Project	IEEE 802.16 Broadband Wireless Access Working Group < http://ieee802.org/16 >	
Title	Inter-Base Station Coordination for Interference Management	
Date Submitted	2008-05-12	
Source(s)	Krishna Balachandran, Mark Doll, Howard Huang, Srinivas Kadaba, Kemal Karakayali, Pantelis Monogioudis, Ashok Rudrapatna, Sivarama Venkatesan	Email: [krishnab, hchuang, skadaba, kemal, monogiou, anr1, sivarama]@alcatel-lucent.com; mark.doll@alcatel-lucent.de
	Alcatel-Lucent	
Re:	IEEE 802.16m-08/016, "Call for Contributions on Project 802.16m System Description Document (SDD)."	
Abstract	This contribution focuses on the MAC/PHY protocol architecture needed for inter-base station coordination in 802.16m in order to effectively mitigate interference thereby helping to achieve the spectral efficiency and cell-edge performance goals of 802.16m. In addition to the control and data plane information exchange needed across different base stations, air interface signaling support needed for different interference mitigation techniques is also discussed. The contribution concludes with specific recommendations to amend Section 8 of IEEE 802.16m-08_003r1.

Inter-Base Station Coordination for Interference

Figure 4 The IEEE 802.16m Protocol Structure

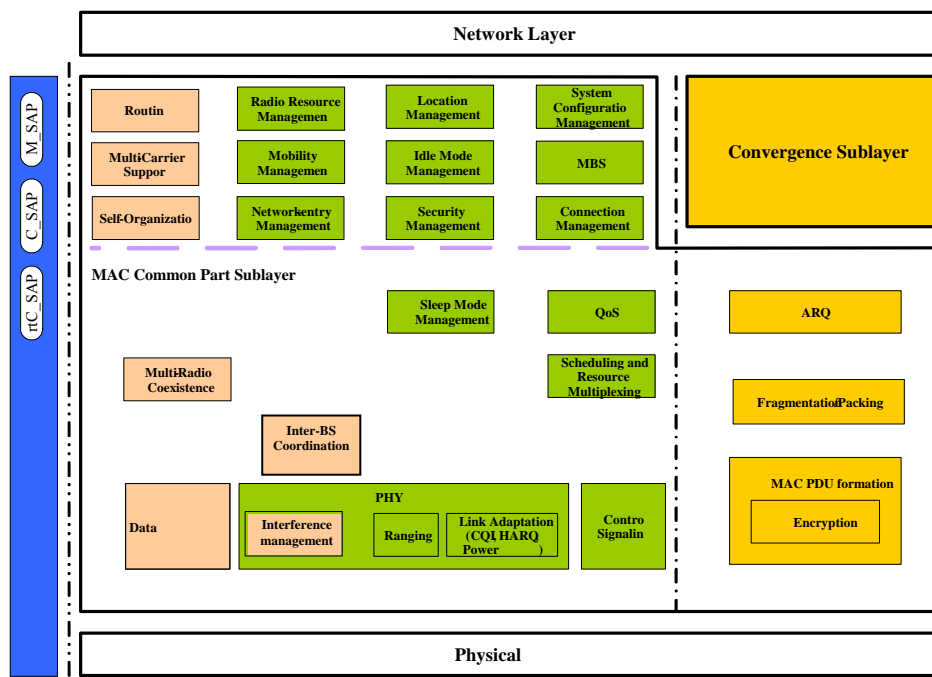
[Rationale: Figures 4 through 6 of the current SDD draft IEEE802.16m-08/003r1 do not currently incorporate the Inter-BS coordination block even though it is mentioned in Section 8.1. The following three figures therefore add the Inter-BS coordination block to the respective figures 4-6 in the SDD. In addition, the real-time constraints of the information exchanged by the Inter-BS coordination block require its separation from other control traffic. This is realized with the new rtC-SAP (real-time control SAP) included in the figures.]

[Use the following figure to replace Figure 4 in IEEE 802.16m-08_003r1]

Figure 5 The IEEE 802.16m MS/BS Data Plane Processing Flow

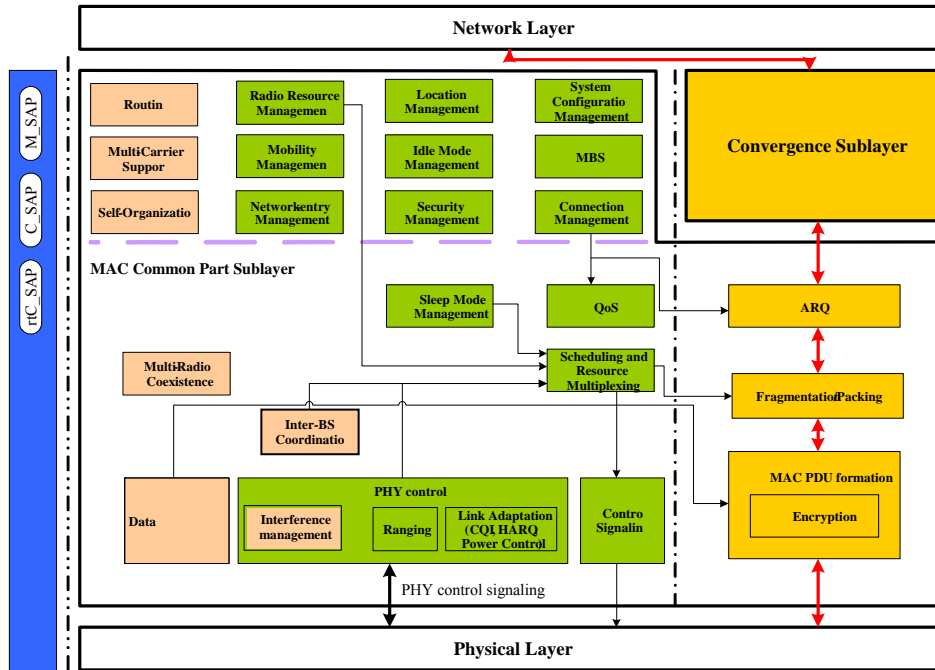
[Use the following figure to replace Figure 5 in IEEE 802.16m-08_003r1]

Figure 6 The IEEE 802.16m MS/BS Control Plane Processing Flow

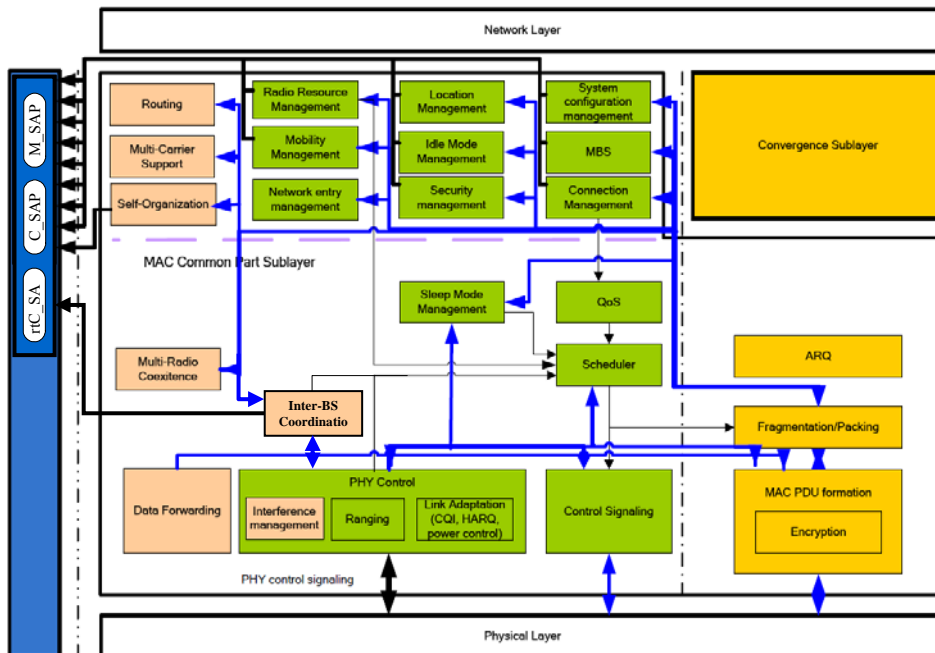
[Use the following figure to replace Figure 6 in IEEE 802.16m-08_003r1]

Figure 8 The IEEE 802.16m inter-base station coordination architecture for downlink operation

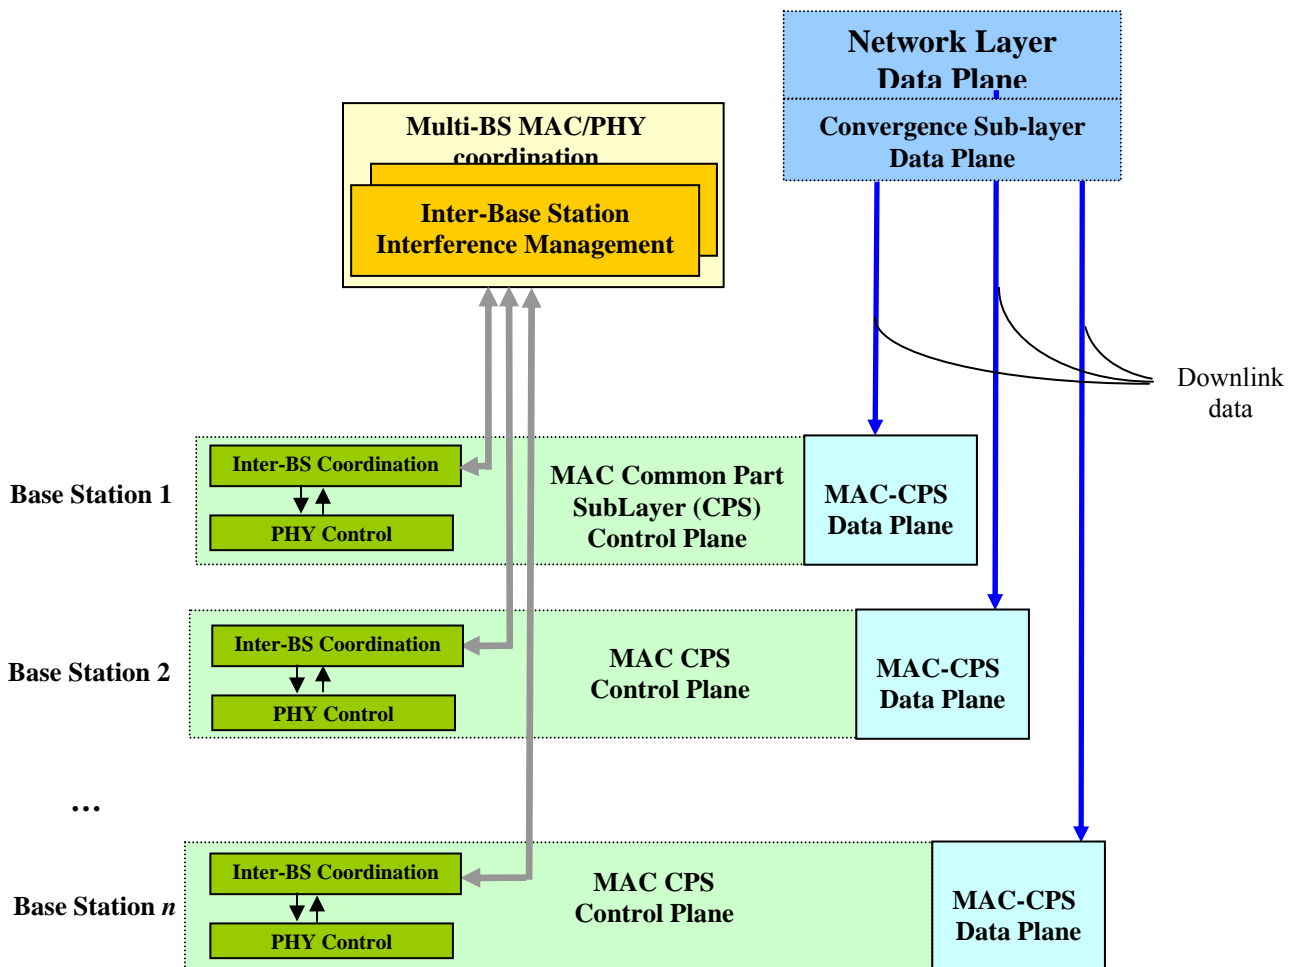
Mere mention of an "Inter-BS coordination" block in the control plane is not sufficient to illustrate how information exchange (control plane and data plane), multi-BS control and data plane information processing may be accomplished. The new Section 8.1.4 with accompanying text and Figures 8-9 introduces a multi-BS Coordination block that provides further clarity to Figures 4-6 in the SDD. The text and figures also explain operation related to inter-BS coordination for interference mitigation.]

[Include the following text and figures in IEEE 802.16m-08_003r1]

In Figure 8, the “Multi-Base Station MAC/PHY coordination” entity is responsible for managing all control plane information exchange (obtained from “Inter-BS Coordination” within each MAC Common Part Sublayer instance) and processing of control plane information, as applicable to specific downlink inter-base station coordination techniques. In particular, it may include a set of “Inter-Base Station Interference Management” entities that are responsible for managing control signaling exchanges among coordinating base stations.

Figure 9 The IEEE 802.16m inter-base station coordination architecture for uplink operation

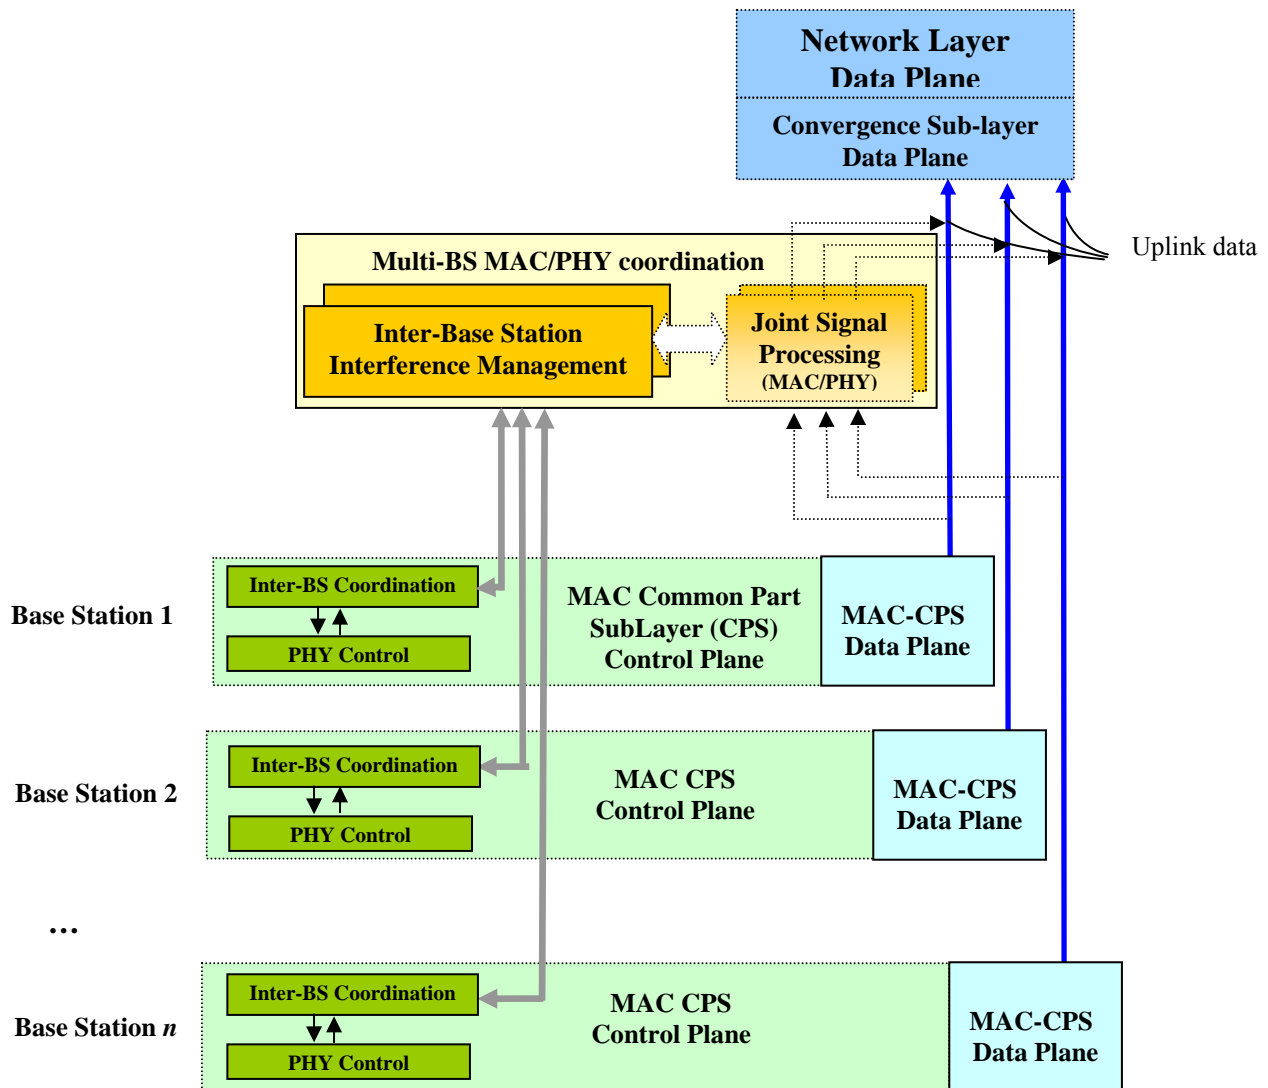
In Figure 9, the “Multi-Base Station MAC/PHY coordination” entity which includes the “Inter-Base Station Interference Management” entity and the “Joint Signal Processing” entity is responsible for managing all inter-base station information exchange and joint processing of control and data plane information, as applicable to specific uplink inter-base station coordination techniques.
